REGATTA VITA SUBDIVISION

APPLICATION NUMBER 8 DATE November 18, 2010

REQUEST Subdivision

DETAIL SITE PLAN

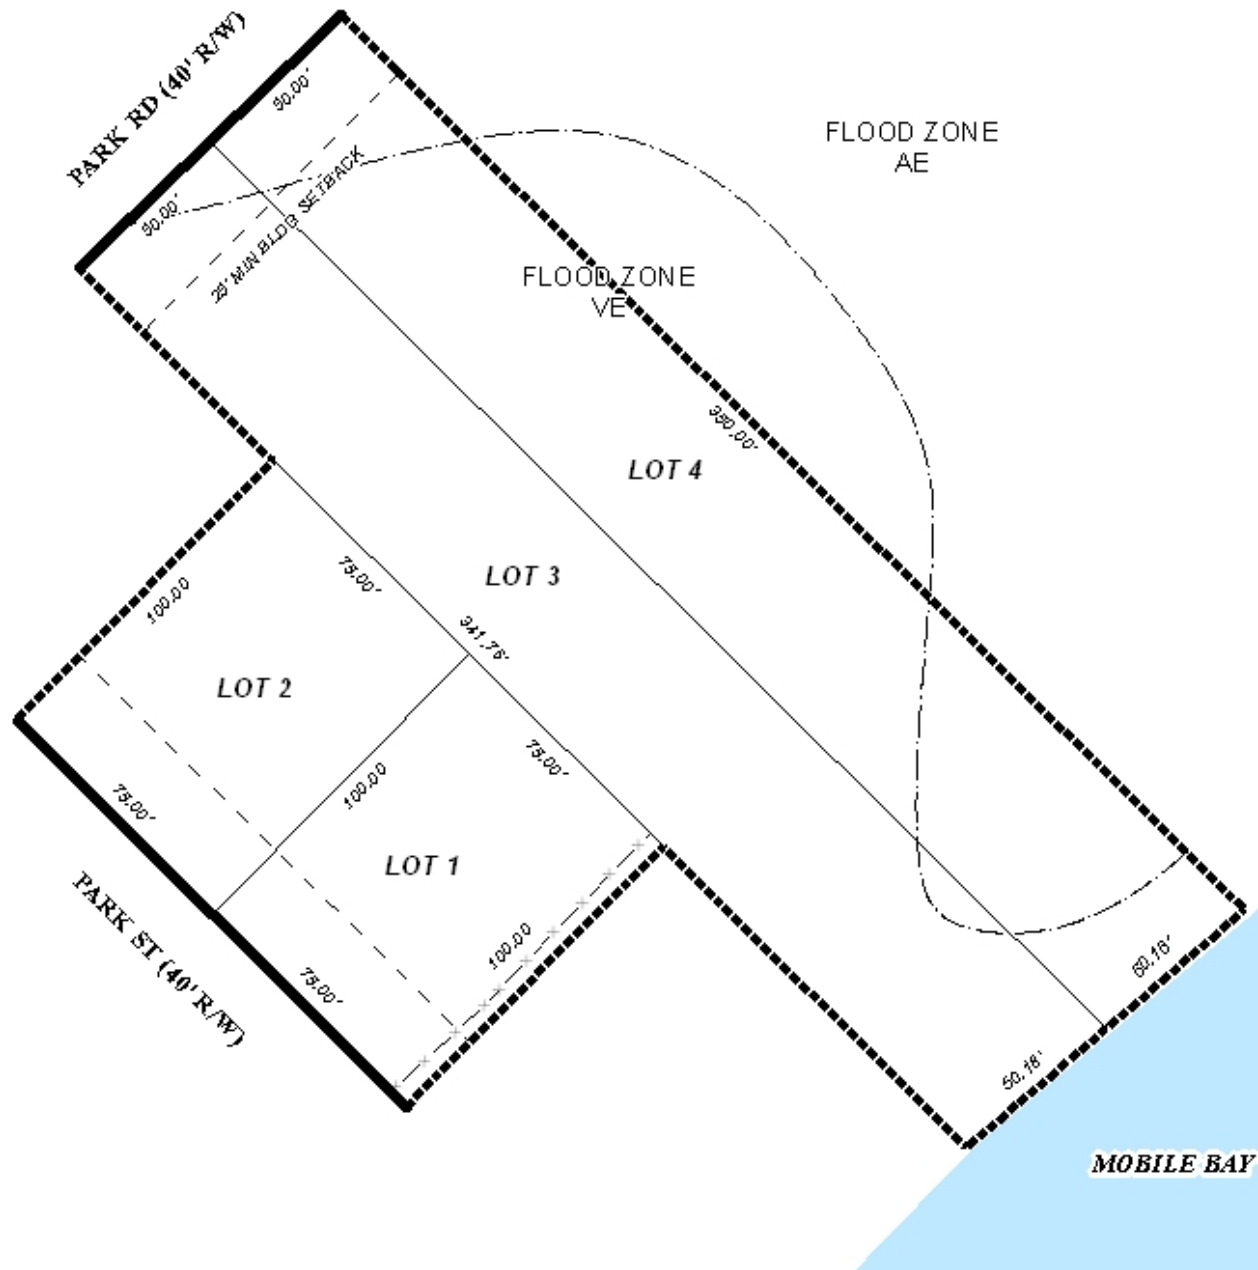
Engineering Comments: Show Minimum Finished Floor Elevation (FFE) on each lot on Plat. Need to verify location of AE/VE line scaling from FIRM maps (3-17-2010), there appears to be a minor discrepancy between line location on plat compared to FIRM map. Any proposed structure shall be constructed on pilings with the bottom of the lowest horizontal structural member to be placed above Minimum FFE. Add note to plat that there is to be absolutely no fill placed within the limits of the flood plain. Must comply with all storm water and flood control ordinances. Any work performed in the right of way will require a right of way permit.

The proposed lots 3 and 4, as depicted, do not meet the minimum frontage requirement as regulated by Section V.D.2. of the Subdivision Regulations, as the proposed lots are depicted with 50 feet of frontage; a minimum of 60 feet of frontage is required. Both of these proposed lots were originally platted with the same dimensions as proposed as Lots 26 and 27, Block 1, Alba Beach Subdivision. The re-platting is not necessary, and these lots could, in fact, be excluded from this application. However, if the applicant wishes for these lots to remain on the plat, a waiver as Section V.D.2. as it relates to the minimum frontage requirement may be appropriate. Both of the proposed lots meet the minimum lot size requirements of the Subdivision Regulations.

Regarding the proposed Lots 1 and 2, the lots, as depicted, meet the minimum size and frontage requirements as regulated by the Subdivision Regulations. However, the proposed lots have frontage on a street with a substandard right-of-way. The proposed lots front Park Street, a minor street not provided with curb and gutter. Park Street is depicted as having a 40-foot wide right-of-way. Section V.B.14. of the Subdivision Regulations requires a minor street without curb and gutter to have a minimum right-of-way width of 60 feet. As such, dedication sufficient to provide 30 feet from the centerline will be required. This dedication would reduce the

proposed lot sizes from 7,500 square feet to 6,750 square feet, below the minimum required lot size.

As stated previously, the site has frontage on Park Road to the West and Park Street to the South. Both roadways are minor streets, not provided with curb and gutter, and both are depicted with an existing right-of-way of 40 feet. The Subdivision Regulations require minor streets without curb and gutter to have a minimum right-of-way of 60 feet; as such, dedication sufficient to provide 30 feet from the centerline should be required.

Additionally, the entire subdivision is located within a FEMA designated coastal hazard flood zone. This may indicate that dense residential development may not be appropriate in this area.

Given that proposed Lots 1 and 2 will fall below the required minimum lot size requirement and the site's situation regarding coastal flood hazard, the two new lots may be inappropriate.

- 1) with required dedications, Lots 1 and 2 will not meet the minimum size requirements; and
- 2) the substandard lots are located within a FEMA designated flood zone with coastal hazard, and thus the property may be proposed for overdevelopment.
